Project	IEEE 802.16 Broadband Wireless Access Working Group < http://ieee802.org/16 >	
Title	Comments on MS Initial Ranging with Non-transparent RS (Centralized)	
Date Submitted	2007-07-05	
Source(s)	Kanchei (Ken) Loa, Yi-Hsueh Tsai, Yung-Ting Lee, Hua-Chiang Yin, Shiann-Tsong Sheu, Youn-Tai Lee, Institute for Information Industry 8F, No. 218, Sec. 2, Dunhua S. Rd., Taipei City 106, Taiwan	Voice: +886-2-27399616 Fax: +886-2-23782328 loa@nmi.iii.org.tw
Re:	IEEE 802.16j-07/019: "Call for Technical Comments Regarding IEEE Project 802.16j"	
Abstract	This contribution proposes modifications for MS Initial Ranging with Non-transparent RS	
Purpose	Text proposal for 802.16j Baseline Document.	
Notice	<i>This document does not represent the agreed views of the IEEE 802.16 Working Group or any of its subgroups. It represents only the views of the participants listed in the "Source(s)" field above. It is offered as a basis for discussion. It is not binding on the contributor(s), who reserve(s) the right to add, amend or withdraw material contained herein.</i>

Comments on MS Initial Ranging with Non-transparent RS

Figure 95e Handle CDMA Initial Ranging Code at Non-transparent RS

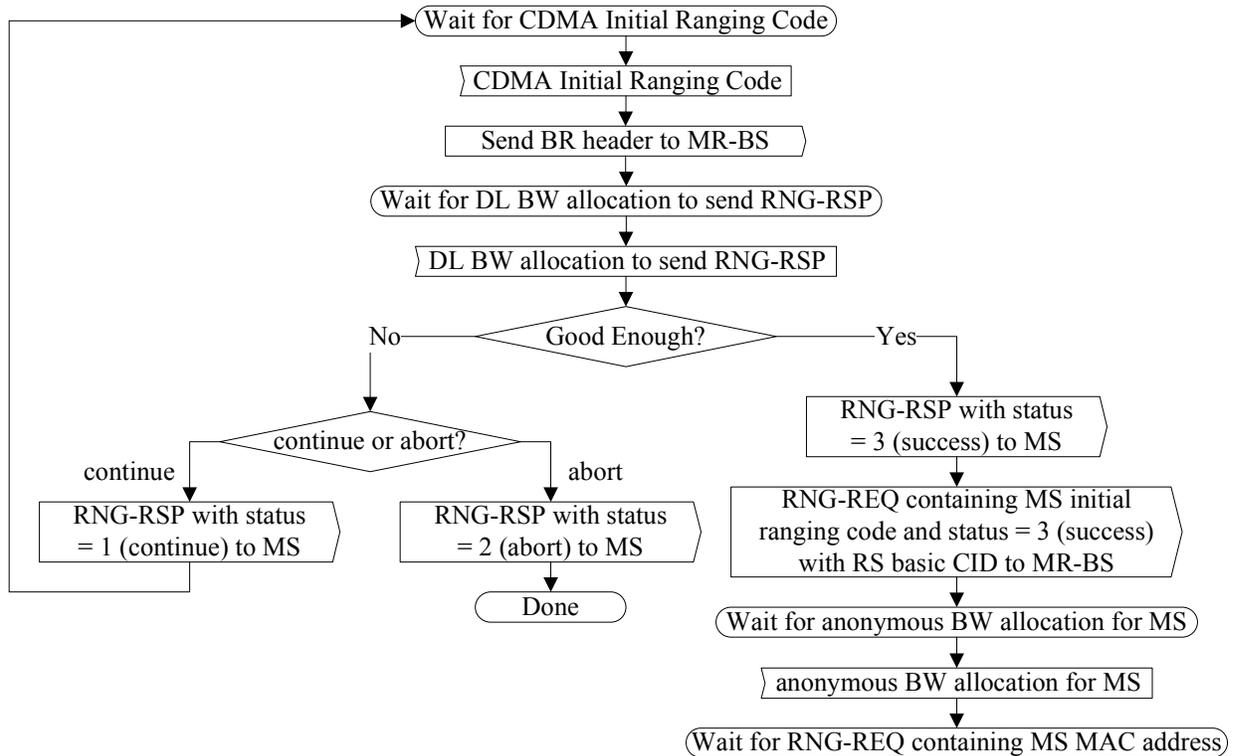
The message sequences chart (Table ~~xxx-1~~199b) and flow charts (Figure 95e, Figure 95f, Figure 95g) on the following pages defines the ranging and adjustment process that shall be followed by compliant RSs and MR-BSs. For CDMA ranging process between RS and MS, these details can be found in 6.3.10.3.

[Insert the following figures at the end of subclause 6.3.9.16.2.1:]
